FOREST TRAVEL MAP

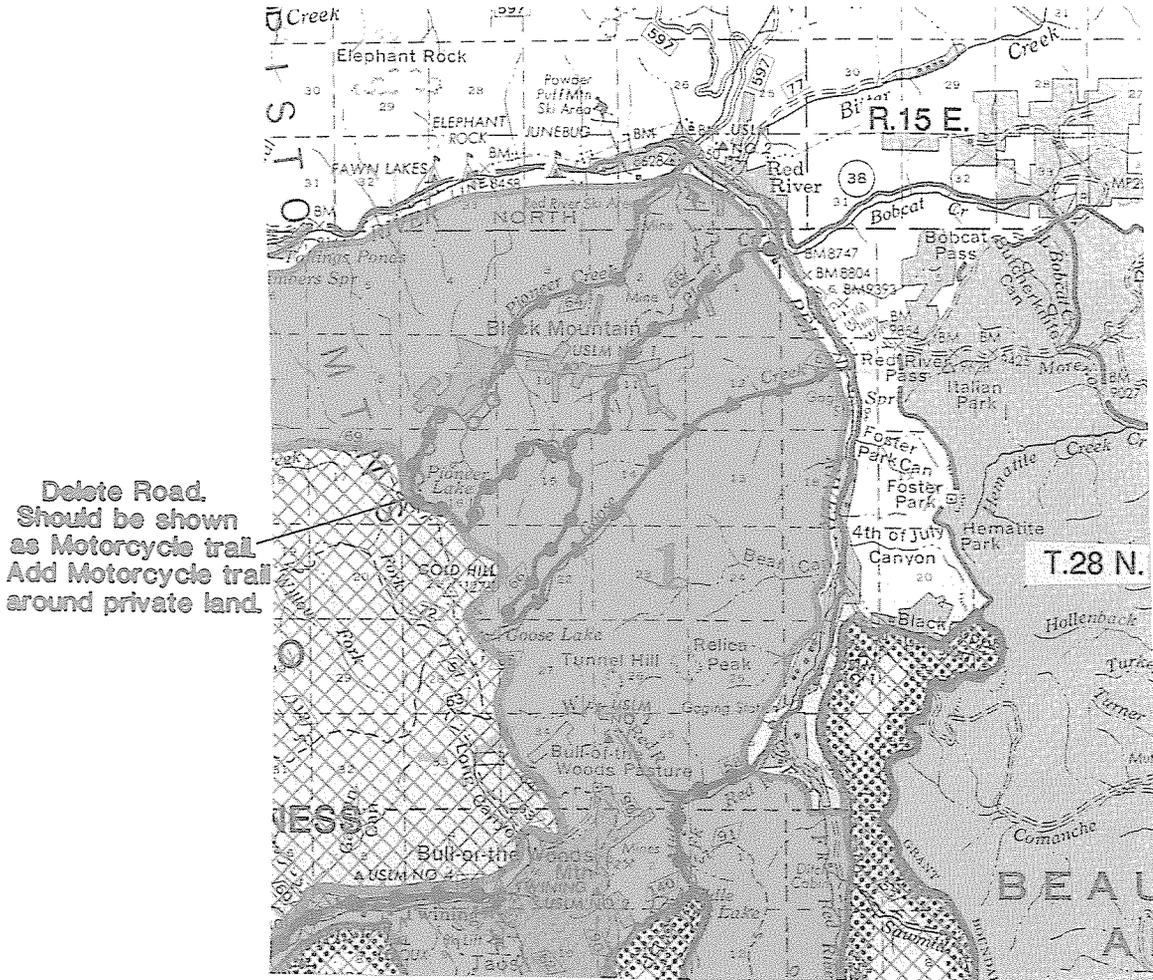
1. This change consists of adding the existing snowmobile trail as a motorcycle/mountain bike trail. This will provide an alternate route to the Garcia Park area and provide safer access to those who must now travel on the heavily used Garcia Park road.

2. The trails are now used by snowmobilers but were not shown on the previous Travel Guide.
3. This provides important access between Angel Fire and Valle Escondido for snowmobiles, motorcycles and ATV's.

4. This was an open road used by high clearance vehicles that was resulting in damage to the meadow at Osha Park and impacting wildlife security areas. It also provides access between Valle Escondido and Sipapu. The decision will close a portion of the road to vehicles over 40 inches.

5. Forest Road 440 has washed out and is no longer accessible to vehicles and therefore has been removed from the system. A trail has been added to provide a route between Taos and Sipapu for vehicles 40 inches and narrower.

FOREST TRAVEL MAP

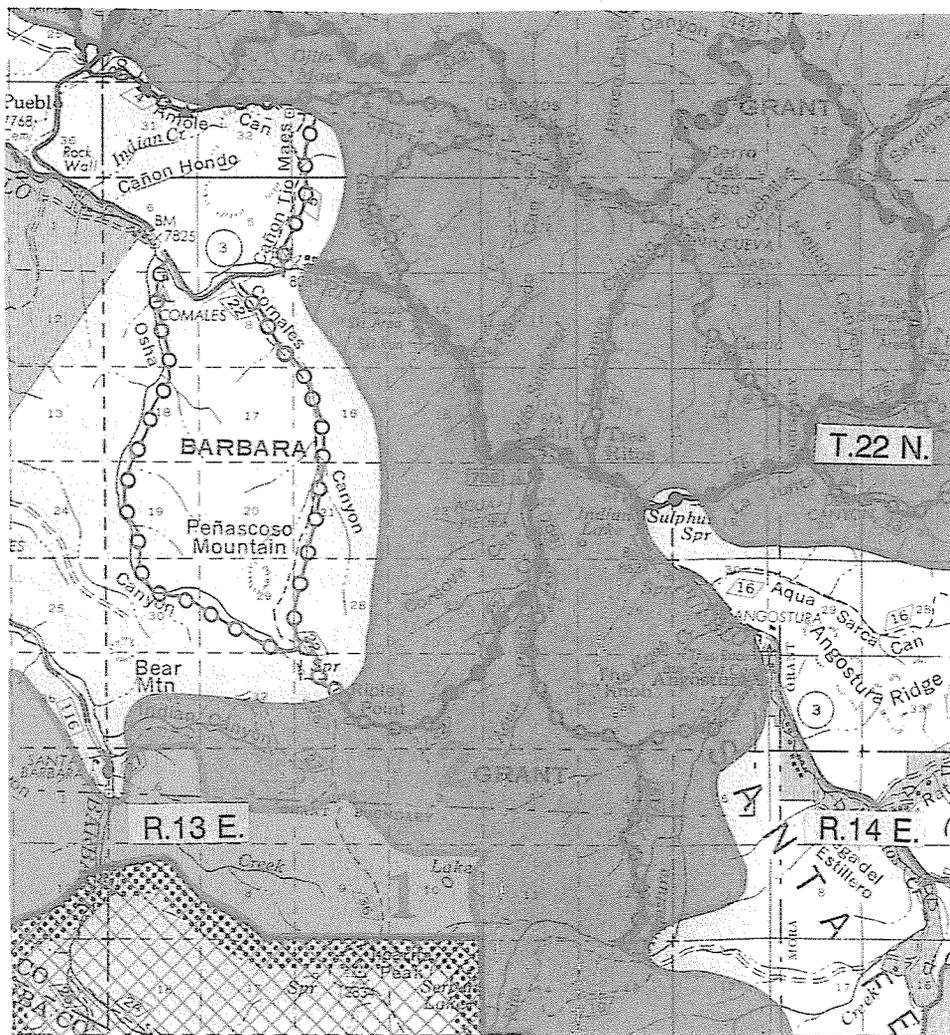
Trail 61 in Angostura Canyon has been deleted as a motorcycle trail to provide wildlife habitat protection. This decision was made as a result of an interdisciplinary analysis of the Angostura Diversity Unit. The additional motorcycle trails shown are not a change since they have always been open to motorcycles. They have been added on the map, even though they are outside the restriction area to let cyclists know where these opportunities are.

FOREST TRAVEL MAP

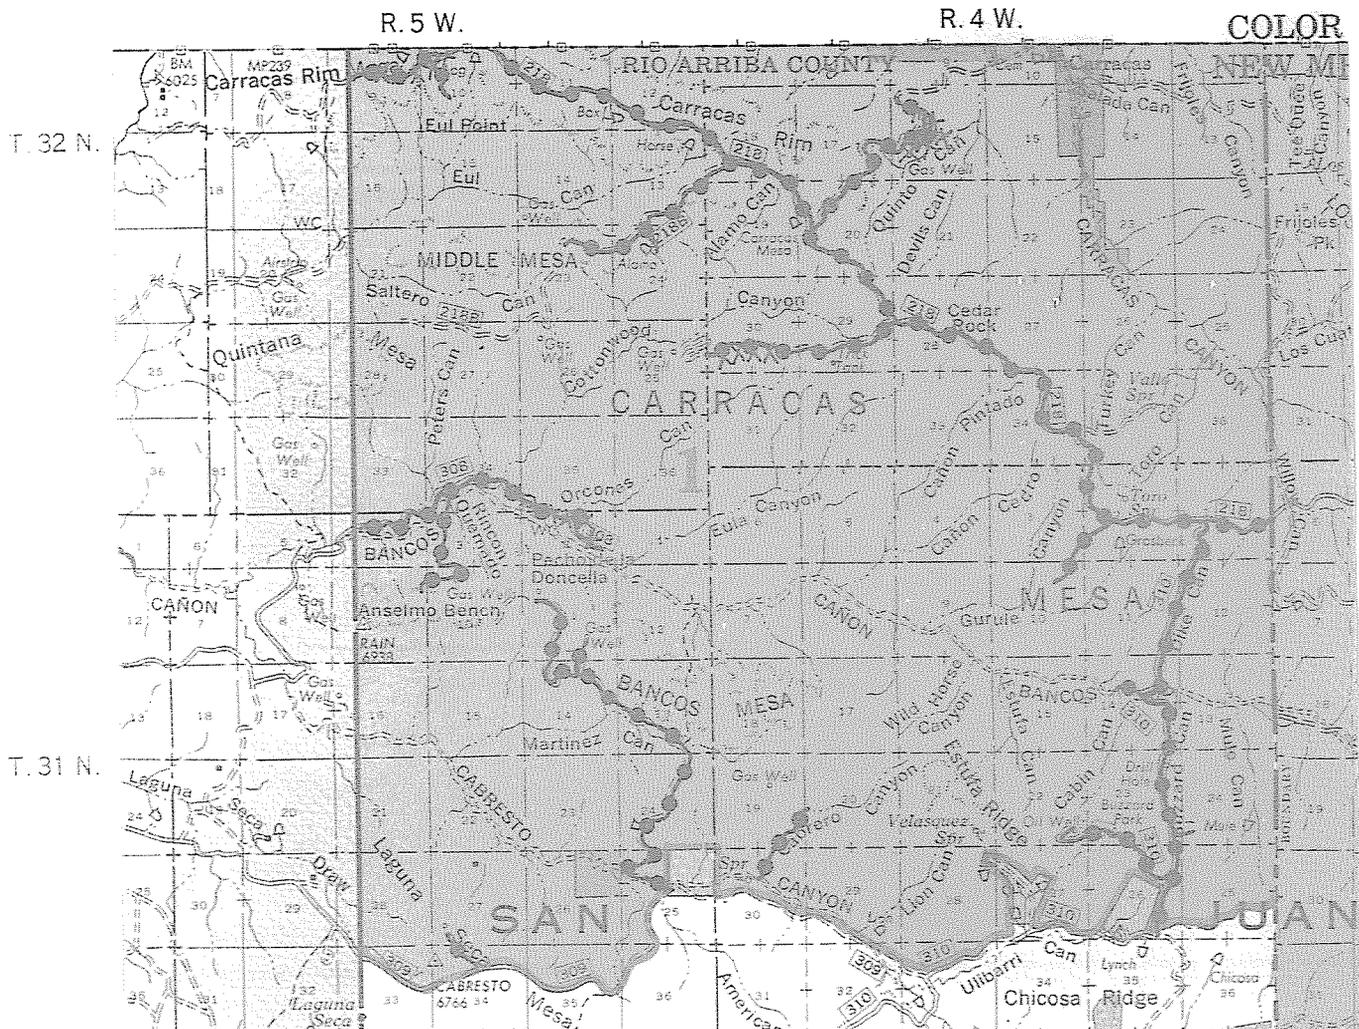
The deletions reflect conditions that have been present on the ground for the last two hunting seasons. They were made to provide additional big game wildlife habitat protection.

FOREST TRAVEL MAP

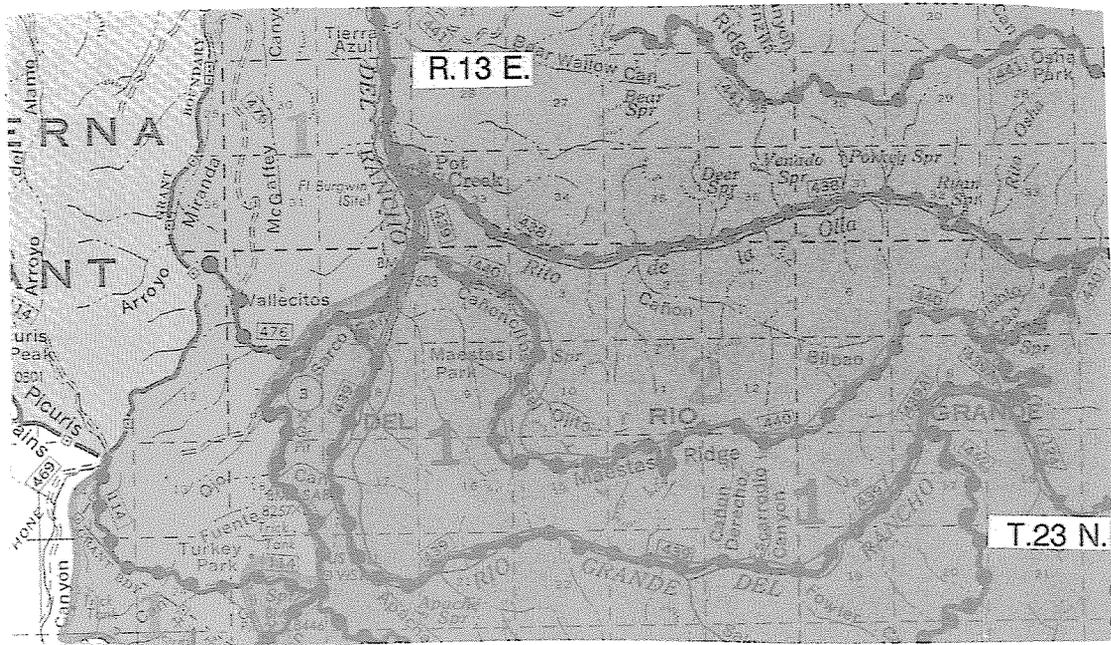
This change adds the Maestas Ridge area to the existing Area 1, which will be closed to all forms of entry from December 26 to March 31 for wildlife habitat protection. This decision was made after three years of monitoring and numerous discussions with snowmobilers, cross-country skiers, and the New Mexico Department of Game and Fish.

FOREST TRAVEL MAP

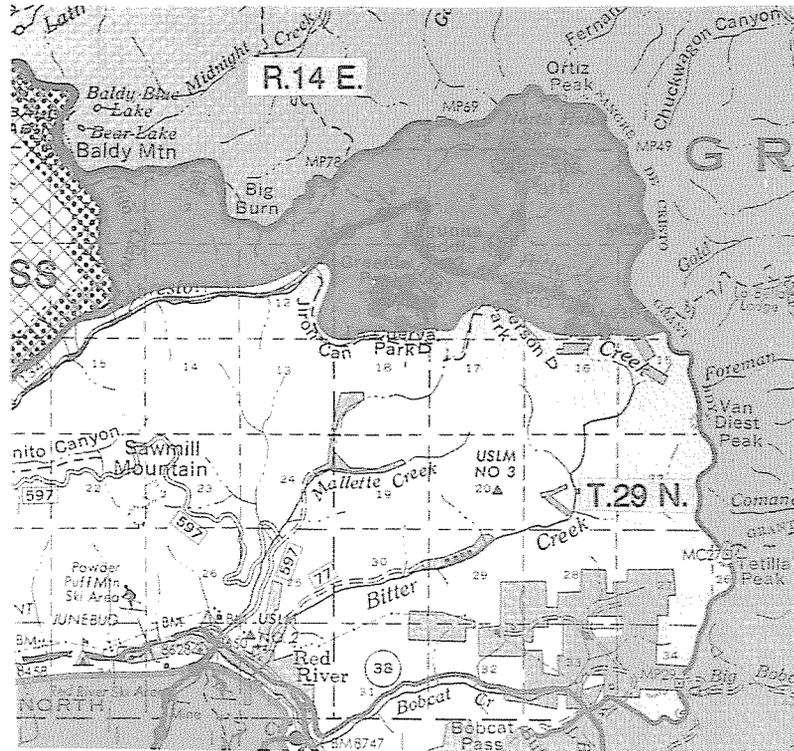
The change on the Greenie Peak loop is made to improve map accuracy. The road deletion in section 9 is made so that vehicles are not encouraged in Bitter Creek Canyon where the road is badly washed out and unsafe.
